Project Name: Mt. Hope School – New BuildProject No.: 221125-140Architect: C2AEDate: 7/31/2023Bid Package No.: 2Bid Due Date: 08/03/2023

Addendum 3

Project No.:	22-0116	Date:	July 28, 2023
Project:	Mt. Hope Lansing School District SB-1785 Ingham County, MI	A/E Firm:	C2AE
Owner:	Lansing School District 519 West Kalamazoo Street Lansing, MI 48933	Project Manager:	Steve Jurczuk

FLOOR PLAN - AREA A
1/8" = 1'-0"

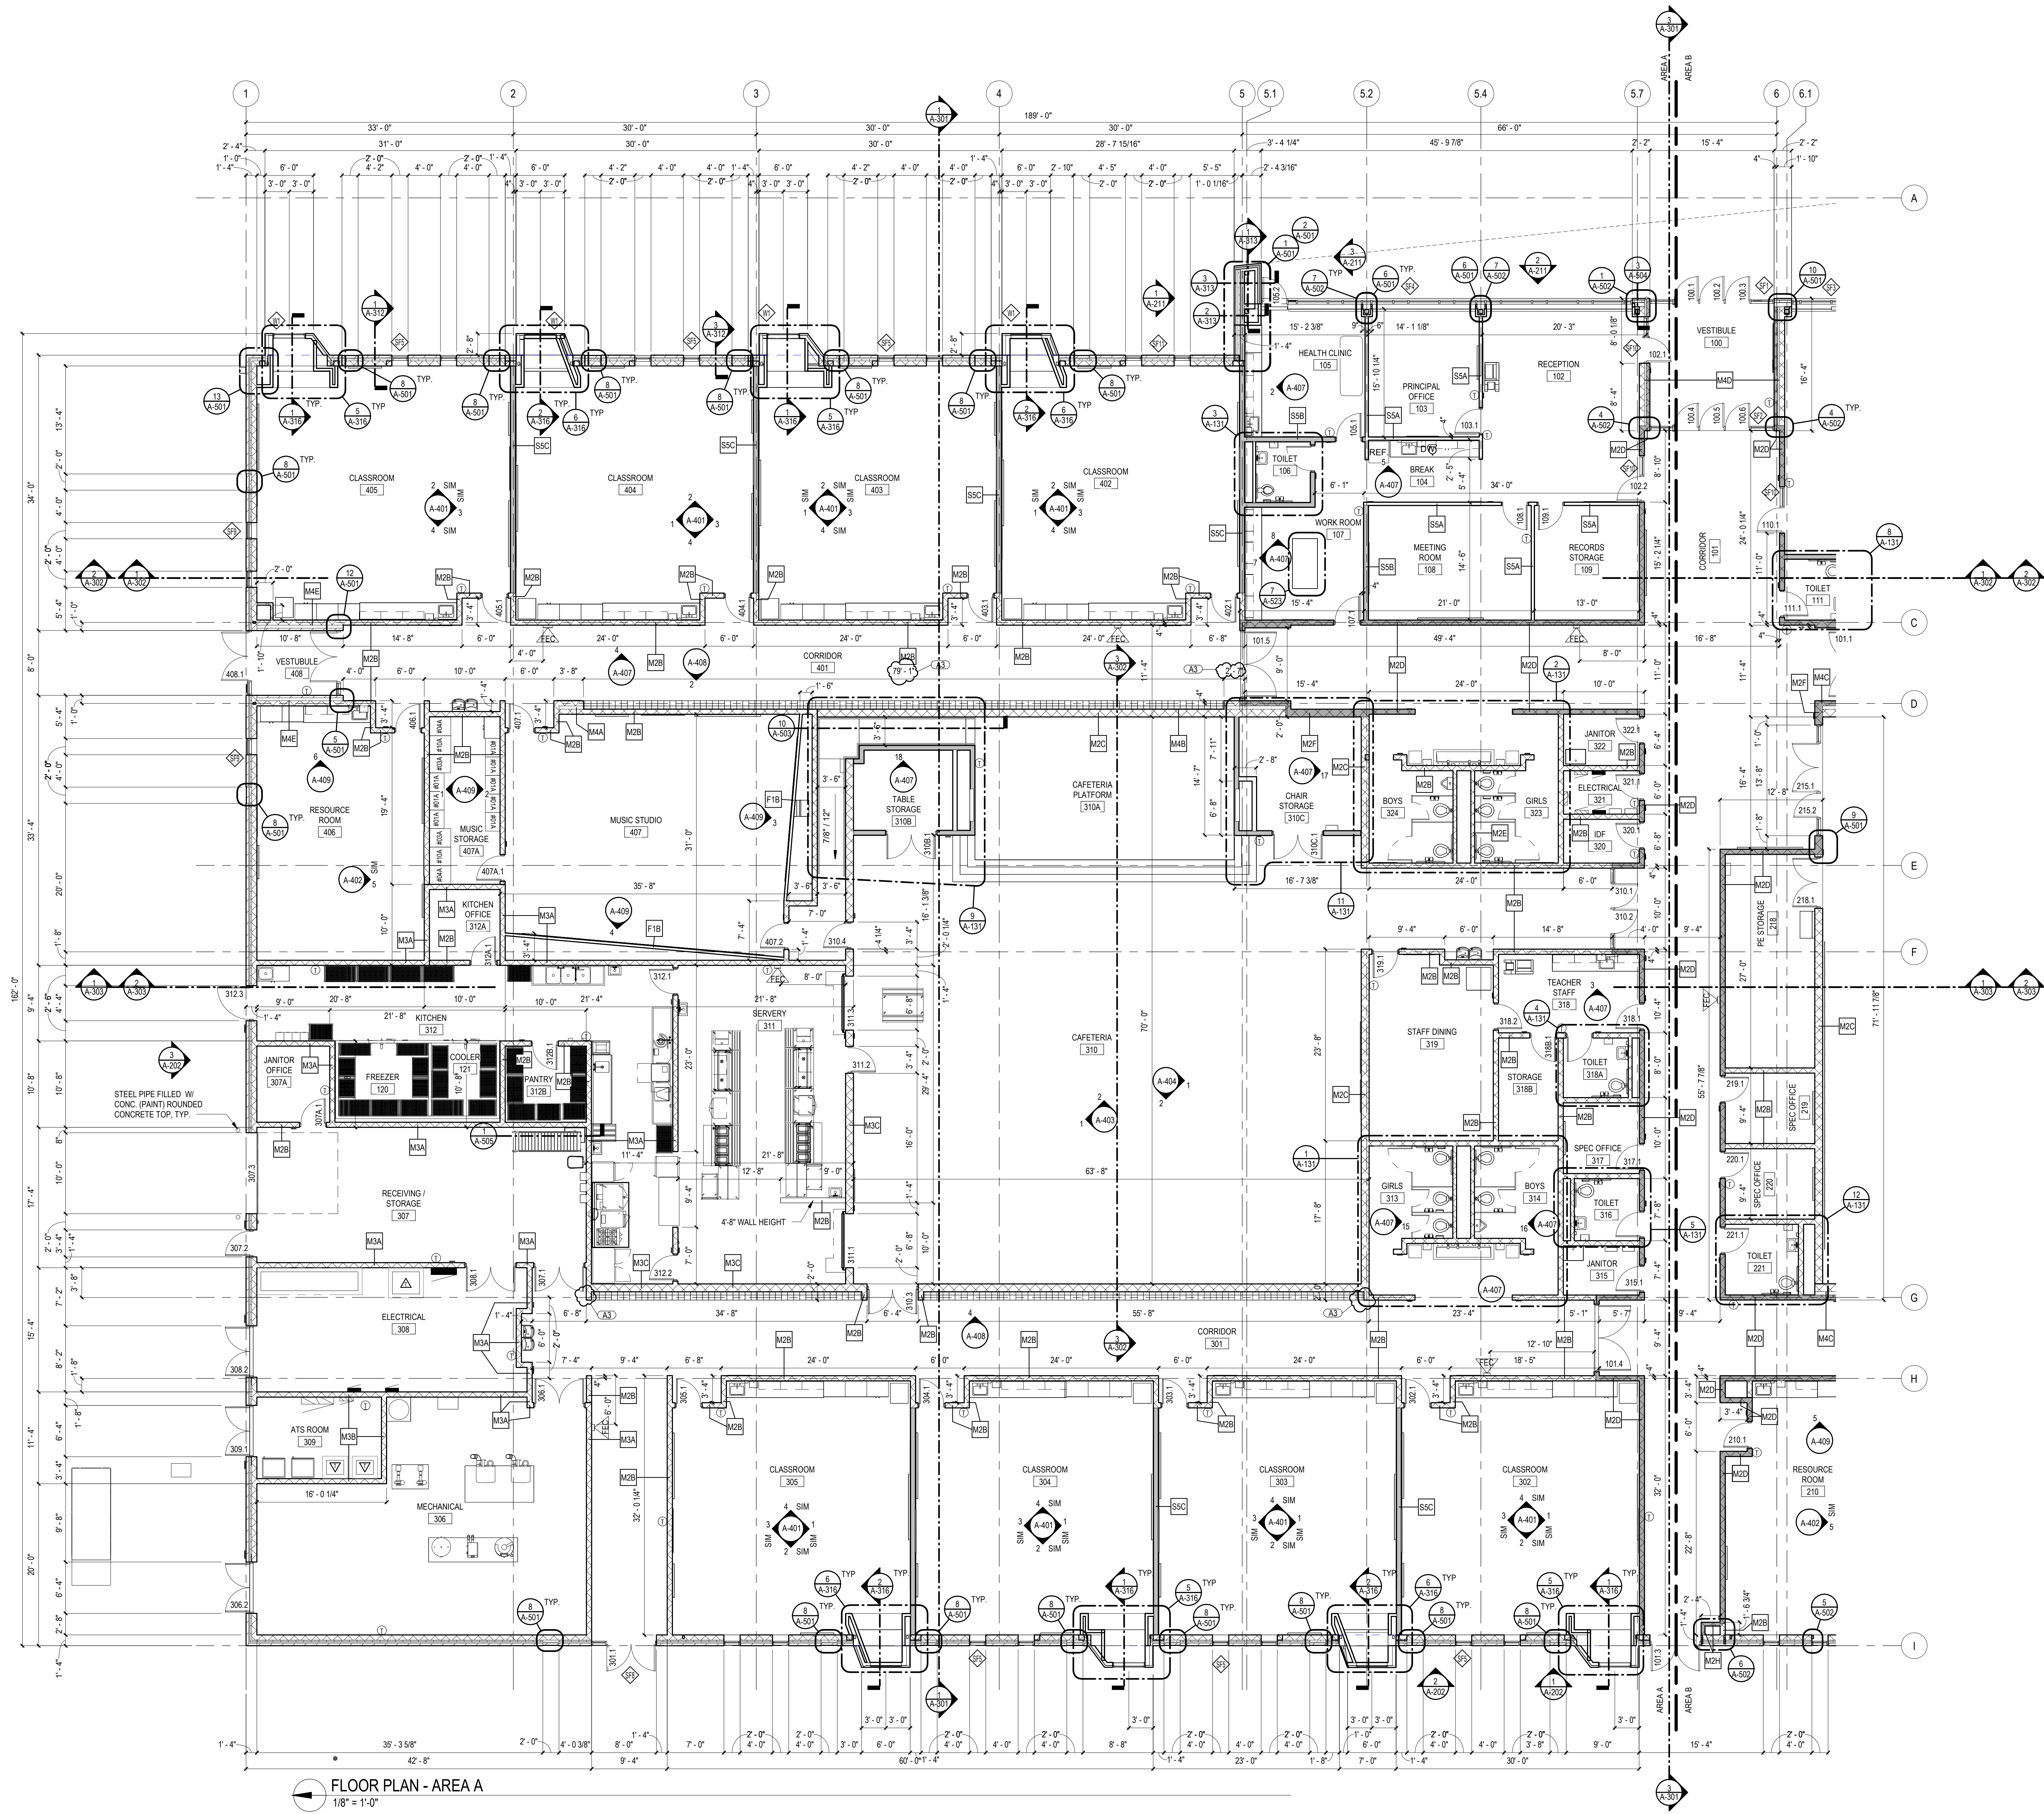
- A3.8 Refer to Sheet S-502 (reissued):
Clarify bond beam locations and elevations.
- A3.9 Refer to Sheet A-001 (reissued):
Partition type clarification.
- A3.10 Refer to Sheets A-101A, A-101B, A-121A, A-121B and A-408 (reissued):
Revise corridor locker layout and size.

4 WALL SECTION - MECH SCREEN SOUTH OF GYM @ SWING GATE
A-1028 3/4" = 1'-0"

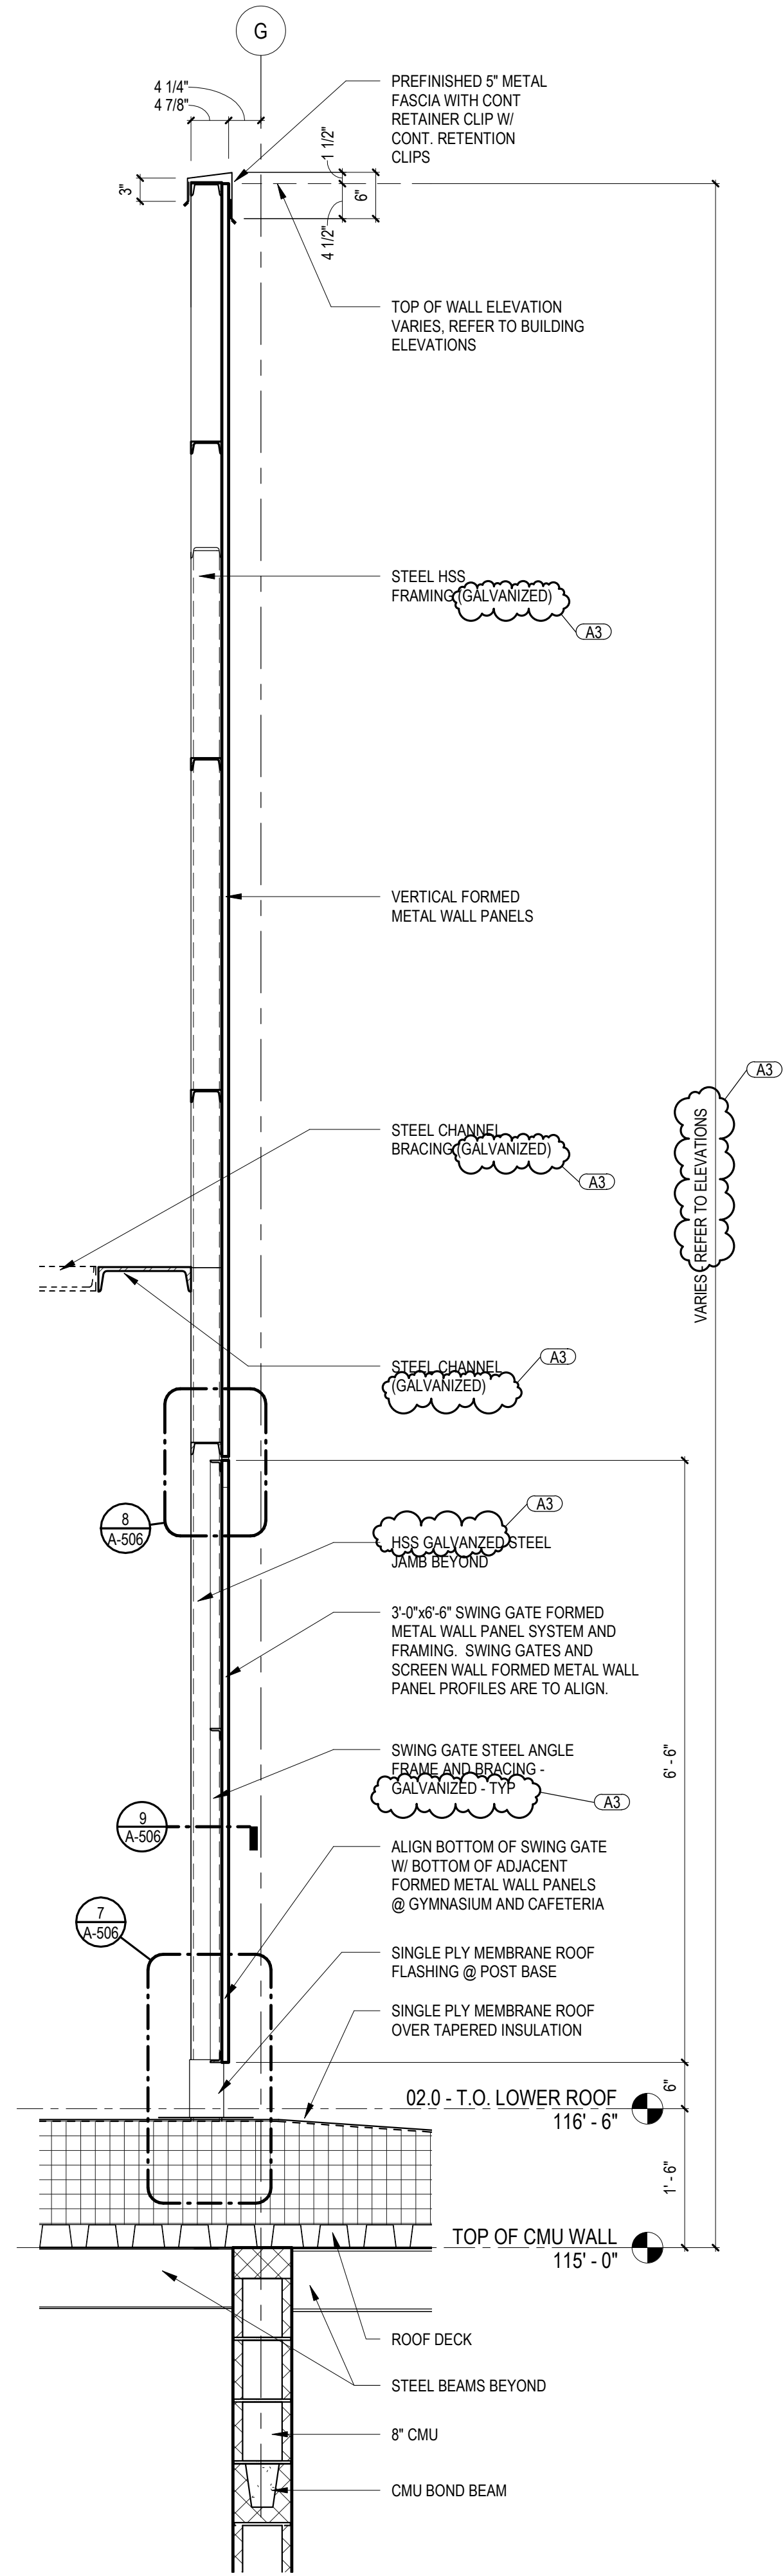
2. Note 10 added to reinforce paint selection for Cafeteria Ceiling Exposed Ductwork.
- A3.13 Refer to Sheet A-314 (reissued):
Detail 4 finish clarification, roof screen steel to be galvanized.
